SUBJECT: Forwards modified responses to Items A.1.3, A.3.1, A.4.10, A.5.8, A.5.9 & A.6.11 of App C, Suppl 1 to NUREG-0843 re control room design, per 821227 telcon. Updated Section 3.1 of "Near-Term OL Summary Human Engineering Rept..." also encl.

Re: St. Lucie Unit No. 2
Docket No. 50-389
FPL/NRC December 27, 1982 Telecommunication
on Control Room Design Review
Supplement 1 of NUREG-0843

RECORD OF PHONE CONVERSATION
December 27, 1982

FIGURE NO. 1

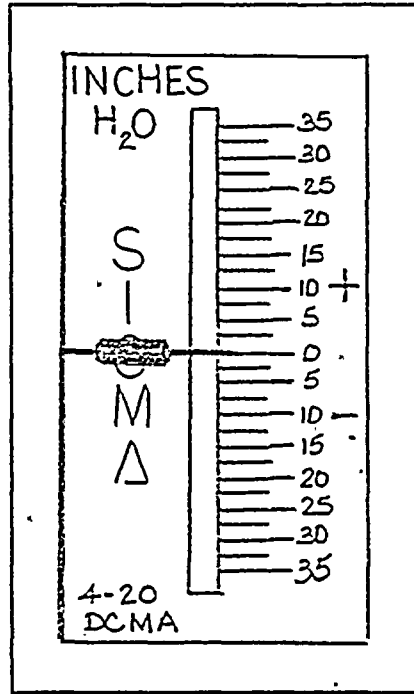
A.5.8 Several meter scales have thick black marks to extend major thick marks to the scale numerals. These marks give the misleading appearance of minus (-) signs in front of the meter scale numerals. (5.11)

During a field review of this item with NRC Field Inspector, Mr. Steve Elrod, it was agreed that the major thick marks on sigma meters did not pose any confusion to the control room operator. Where indicators display positive and negative values the scales are conspicuously marked indicating positive and negative values. Major graduation on sigmas are consistently marked as per the attached Figures 1 & 2. Figure 1 depicts a typical sigma scale showing a negative to positive value scale and Figure 2 depicts a typical sigma scale showing zero to positive values.

"The marks viewed as being minus (-) signs by the field inspection team pose no significant interpretation problem to the control room operator. The subject sigma meter graduations are consistently presented. Where negative and positive values are displayed by indicators minus (-) and plus (+) signs are conspicuously placed on indicator scales. FP&L intends no further action on this item."

FIGURE 3

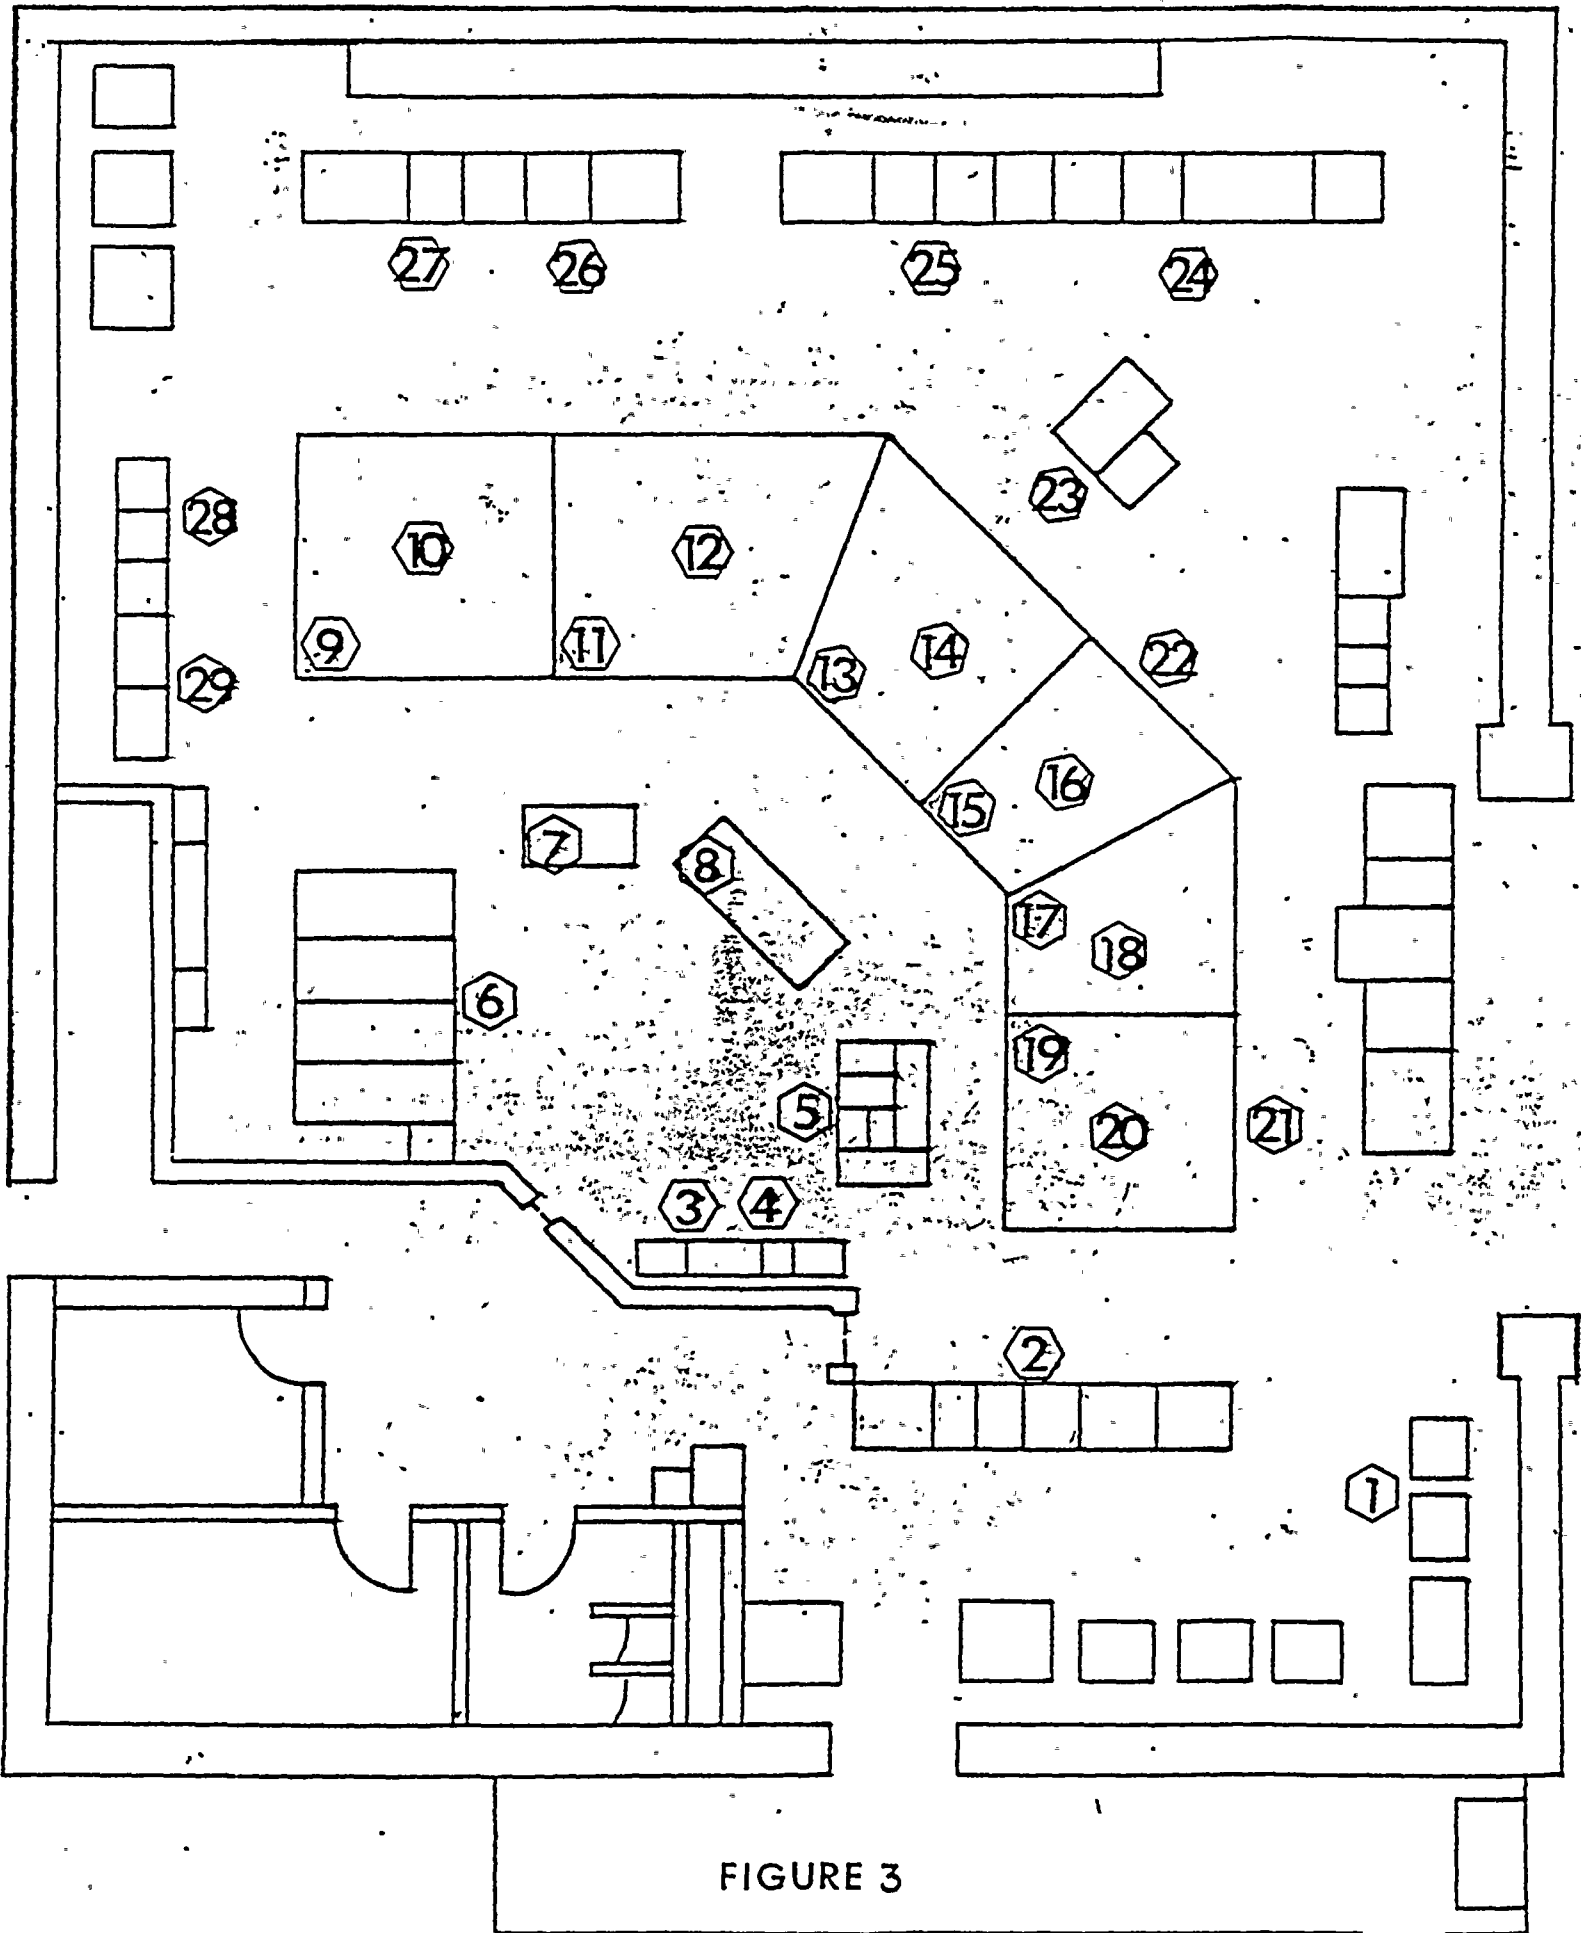
A light survey of the control room was conducted during the month of August, 1982 with the results as previously presented in the NTOL Summary Human Engineering Report dated October 28, 1982. The emergency light levels were found acceptable and the normal AC light levels were to be reduced to approximately 50 ft. candle levels by switching off selected banks of A.C. lights not on the vital AC auto diesel load circuits.

A light survey was conducted January 7, 1983 after normal light levels were reduced. The normal AC light levels were reduced to acceptable levels such that emergency light levels remain unaffected. The normal AC light levels as tested are presented in Figure 3 and table 3.1. It should be noted that where control panels have vertical and horizontal work areas light levels were measured on both planes.

In conclusion, FP&L considers the control room light survey to be satisfactorily complete and intends no further action as part of the Preliminary Control Room Design Review effort.

FIGURE 5

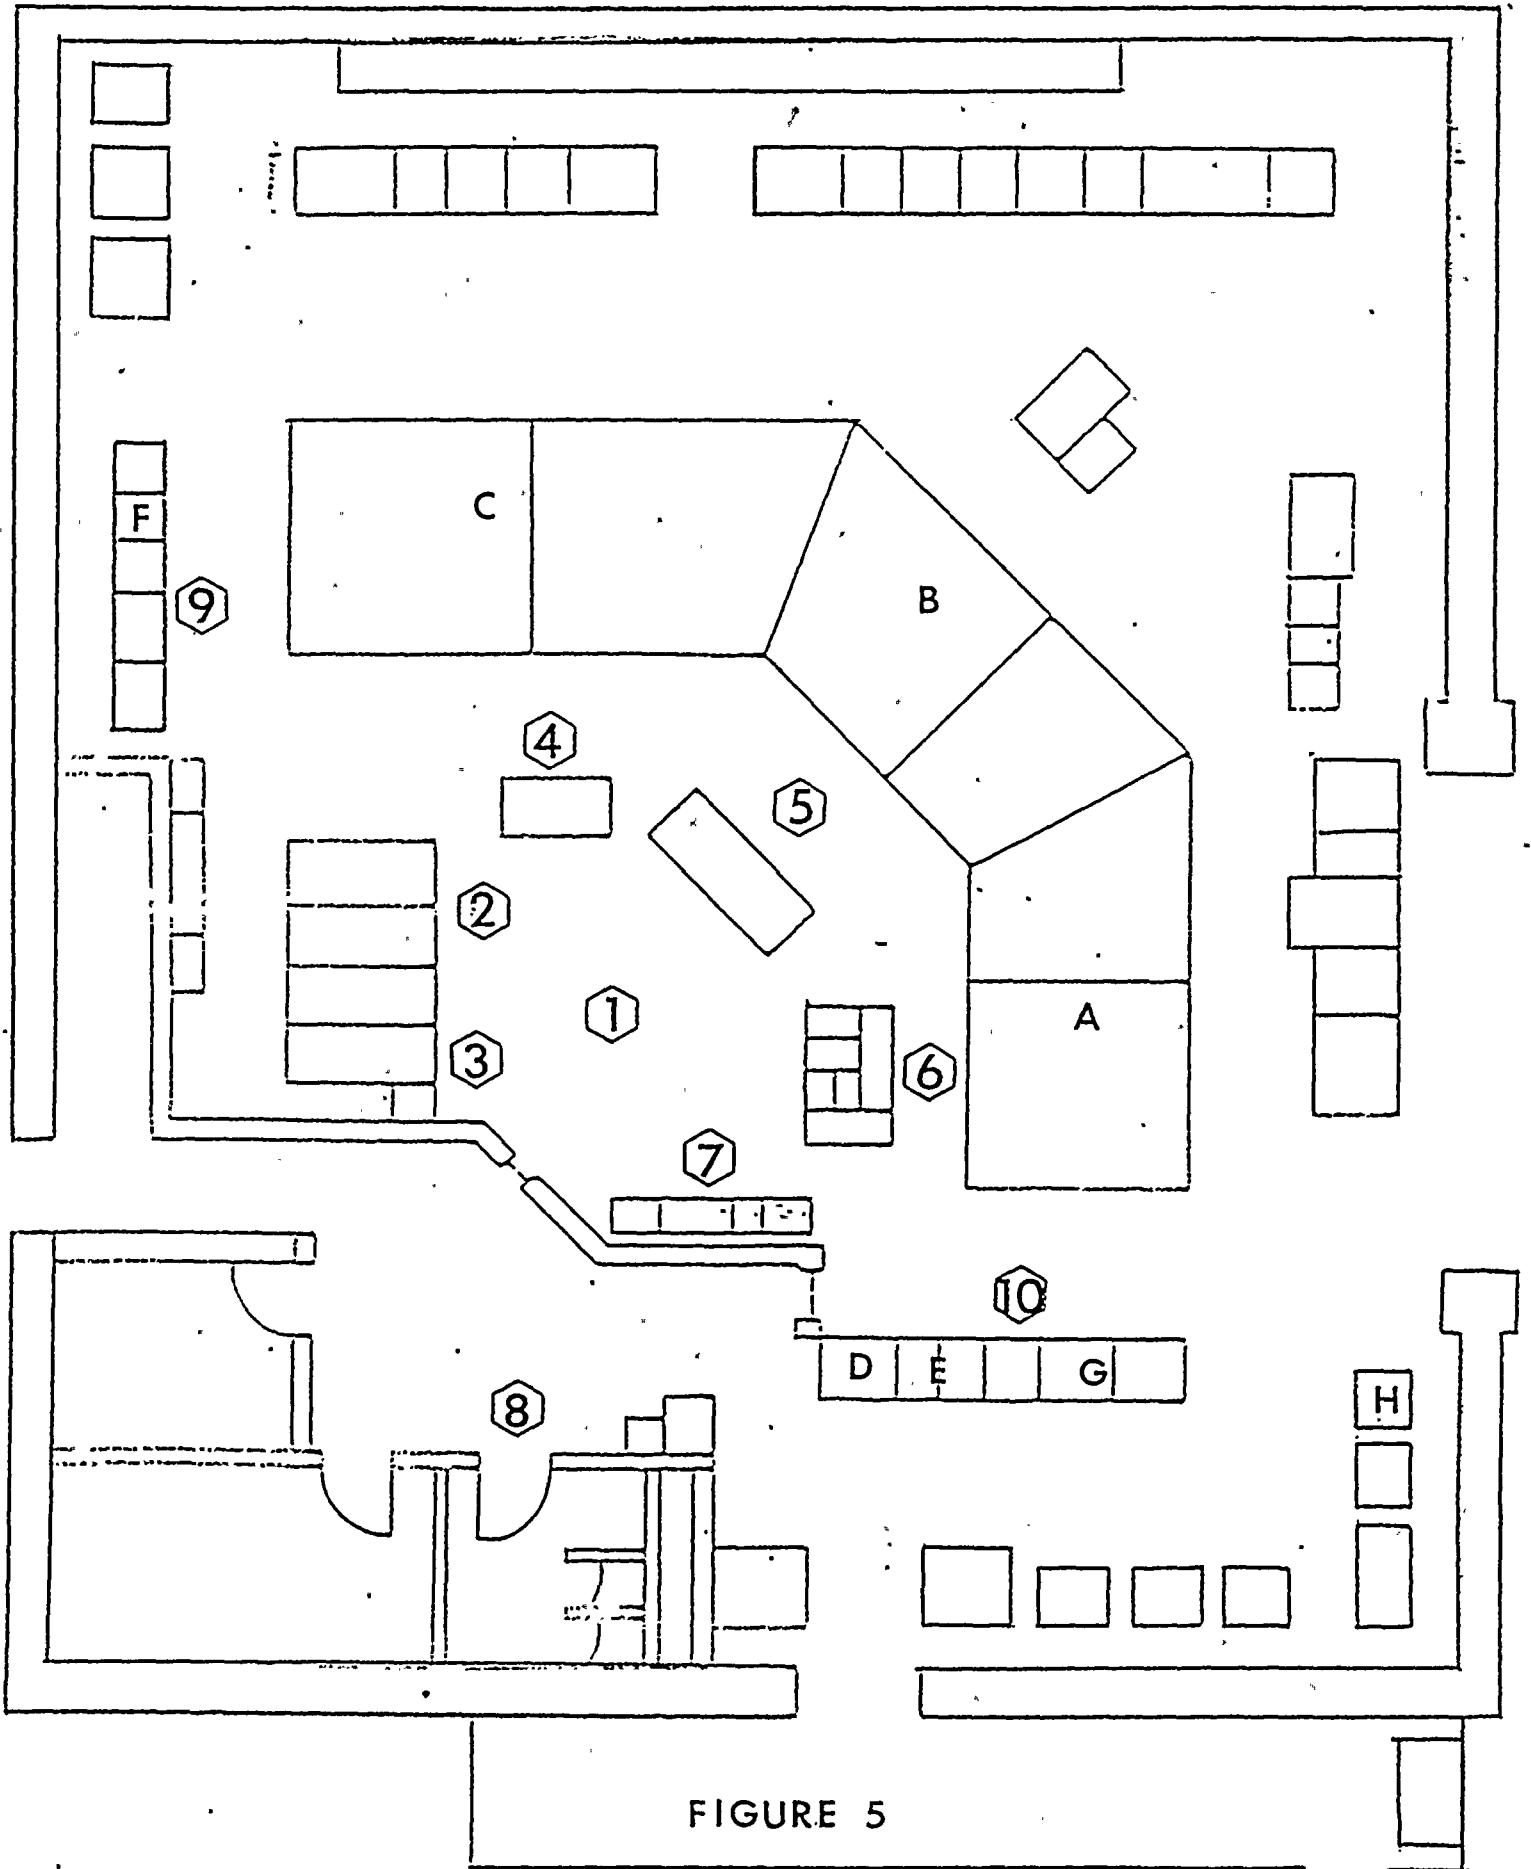
A noise survey of the St. Lucie Unit No. 2 control room was conducted on December 30, 1982. Figure 5 shows the control room locations where sound measurements were taken. Table 5.1 lists the background levels and Table 5.2 lists the panel annunciator levels as measured, at position 1 of Figure 5.

It was determined that the 8 Reactor Protection System cooling fans were the major contributing factor to the observed background noise levels. A second survey was conducted with only 4 of the subject fans running. By reducing the number of cooling fans by half, an approximate 3dbA reduction in background noise level was achieved.

Presently FP&L is reviewing the redesign of the air supply to the reactor protection system and will implement the necessary system design changes to reduce the noise contributed by the subject cooling fans during the first refueling outage.

FP&L will install carpeting in the control room which is expected to help reduce background noise levels. The carpeting will be installed after construction activity in the control room is complete.

FP&L considers the control room sound survey to be complete. The presently installed annunciator sound devices are adjustable and will be raised to 10 dbA above background.
